17/00220/LBC

**Glazed link extension at The Old Rectory Ampney Crucis Cirencester
Gloucestershire GL7 5RY**

Listed Building Consent : 17/00220/LBC	
Applicant:	Mr Stuart McIntyre
Agent:	Mdarchitecture Limited
Case Officer:	Alison Williams
Ward Member(s):	Councillor David Fowles
Committee Date:	12th July 2017
RECOMMENDATION:	REFUSE

Drawing:
 Site & Roof Plan
 as Proposed

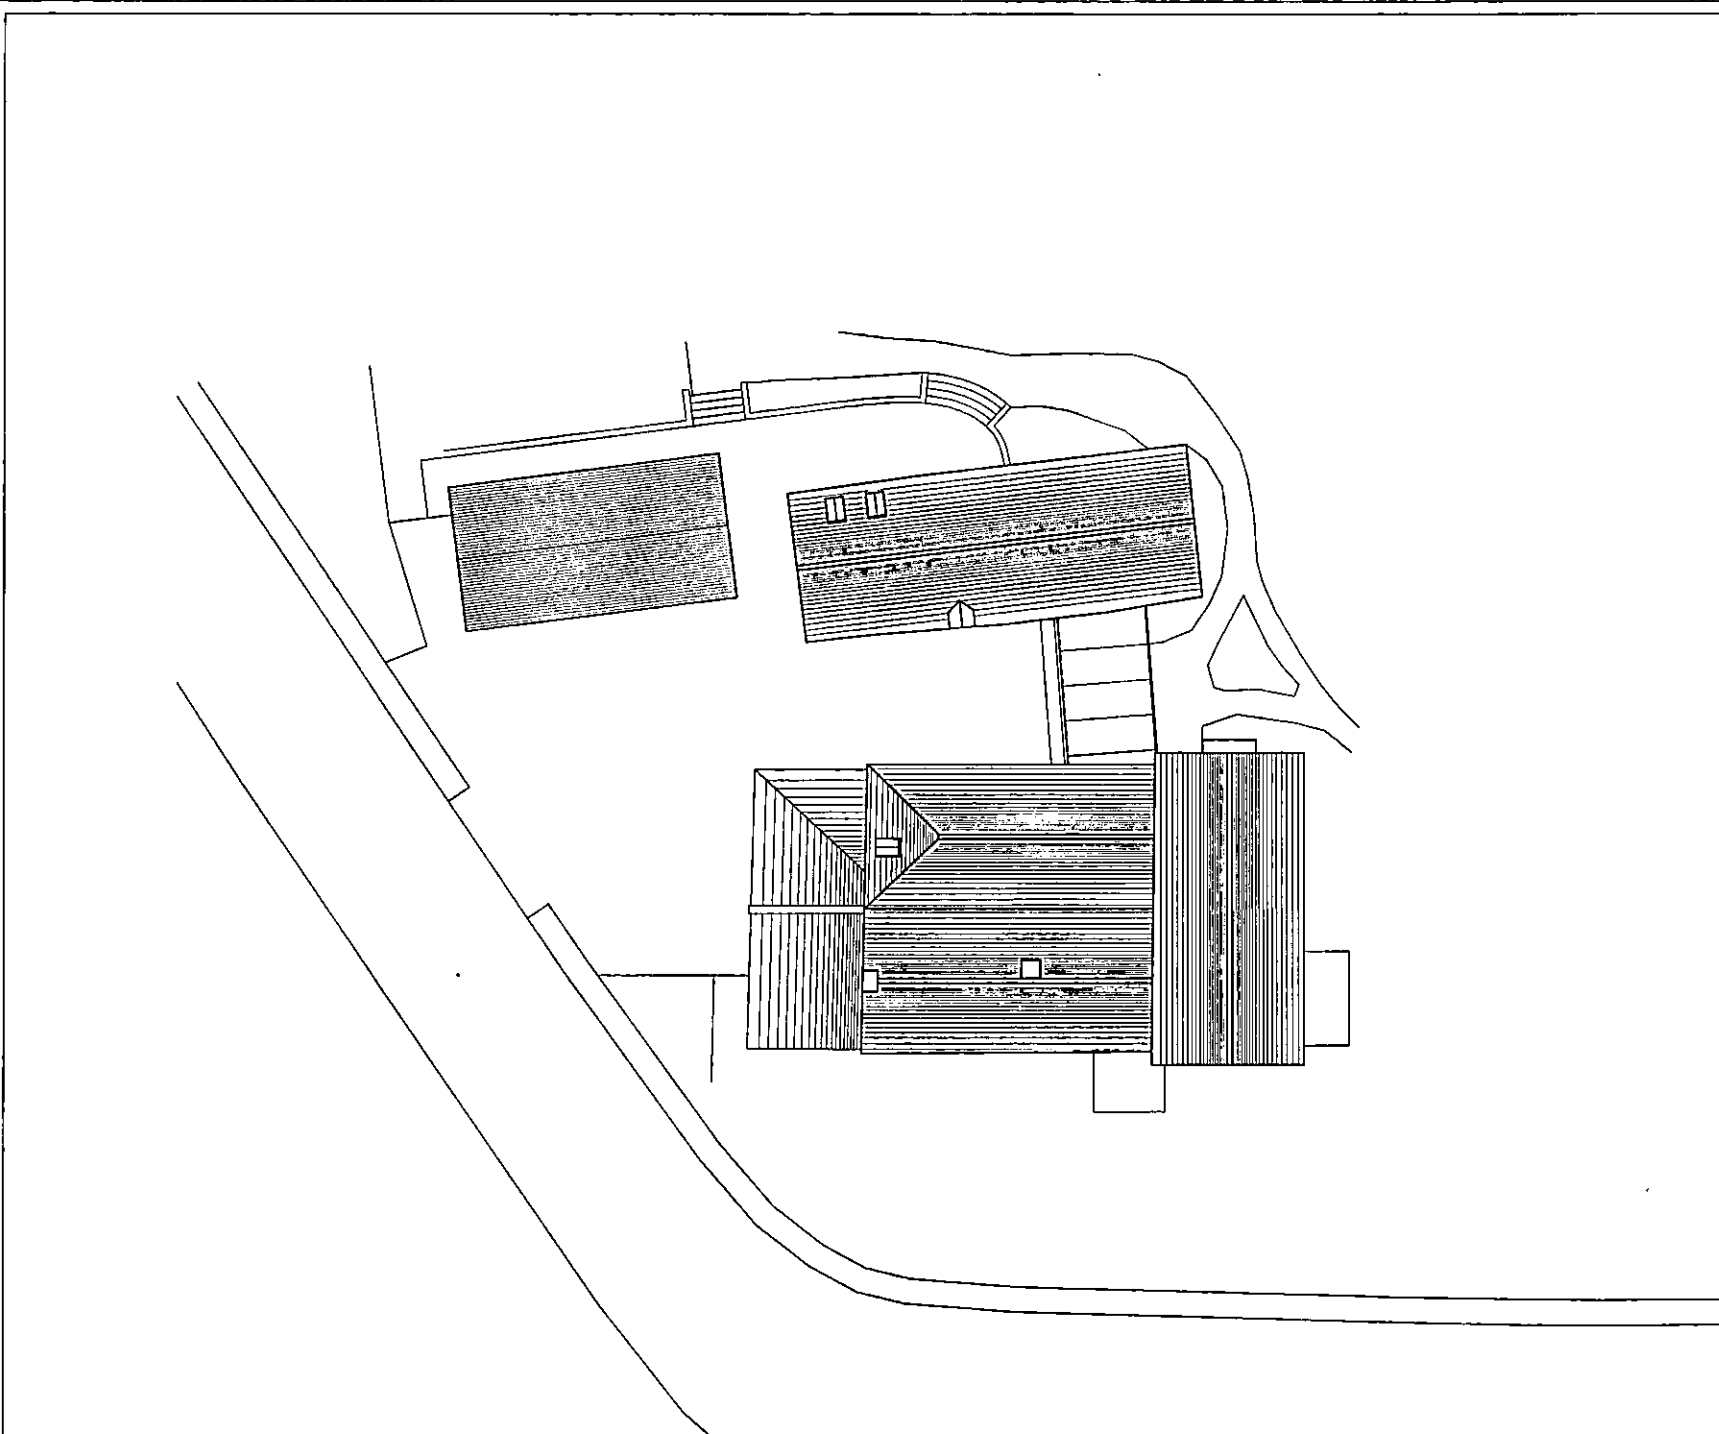
The proposed link between the two buildings would also create the main hall and point of access, as well as a garden room. It would relocate the existing stone wall that connects the two buildings 3.5m further to the east. This wall would then be increased in height from 2.1m to 2.7m with a timber panelled door inserted, which would then allow entrance into the proposed link/summer room and would also serve as the main entrance to the property.

The extension would be formed from frameless fine line aluminium double glazed screens and sliding doors and glazed roof on the eastern elevation. The extension would extend 3.6m in width to the east.

The proposal, through the relocation of the existing wall by 3.5m further to the west, aims to increase the size of the resultant yard, but would at the same time increase the height of the wall, rendering it more prominent in its uncharacteristic division of the yard space. Indeed the boundary wall would no longer be a simple boundary wall but the wall of a garden room, located within the service yard and physically linking the principal dwelling house to its ancillary outbuilding, which historically was characteristically separate both physically and functionally.

The proposed centralisation of the entrance door from the yard into the proposed stone wall of the link extension would, through its location and use of a solid planked door, give added prominence to the link as an entrance feature, rather than a boundary wall with an incidental gate access within it.

Drawing:
 Elevations
 as Proposed

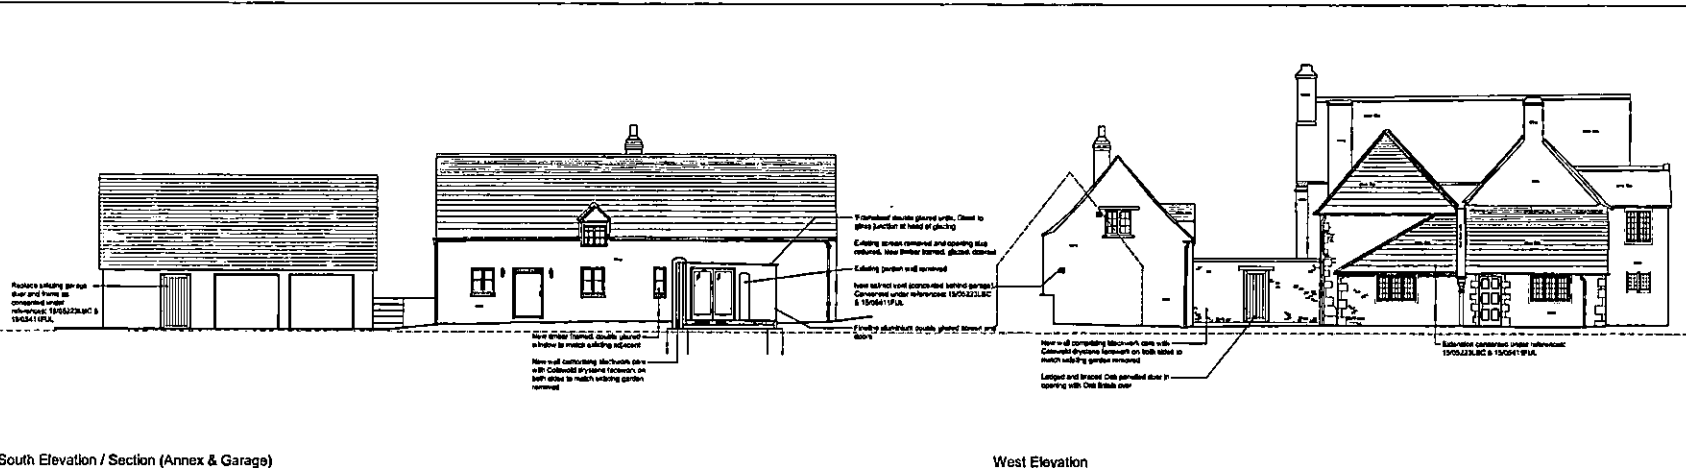
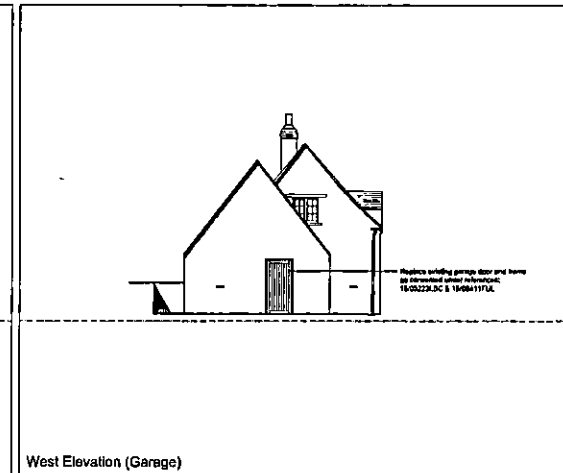
In addition, the relocation of the wall to form the elevation of the garden room/link extension results in the physical alteration of historic fabric and features to the elevations of both the main house and the outbuilding. The Heritage Significance Addendum report submitted with the application provides no clear or convincing evidence that the openings proposed for alteration hold no significance and would not be harmed by the proposals. The current proposals would result in the loss of the door jamb, which appears to be original. In relation to the window and door arrangement to the main house, the existing door appears to be an alteration from a window, but the existing window appears from the photograph to be a historic and architectural part of this elevation. As such, it is considered that there is insufficient justification for the loss of historic fabric to outweigh the harm.
